**ORGANISATION INTERGOUVERNEMENTALE POUR
LES TRANSPORTS INTERNATIONAUX FERROVIAIRES**

3 December 2008

**CORRIGENDUM 1
to the notification texts OTIF/RID/NOT/2009 of 27 June 2008 and
to the printed RID edition 2008**

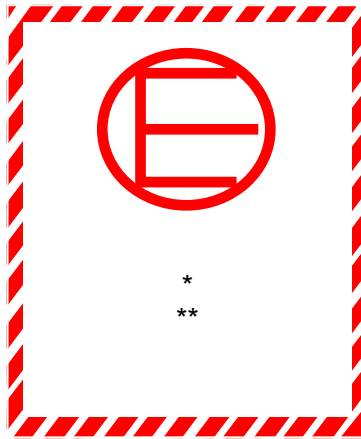
3.5.4.2 Replace the figure with the following (the line in the middle of the letter "E" must not touch the circle):
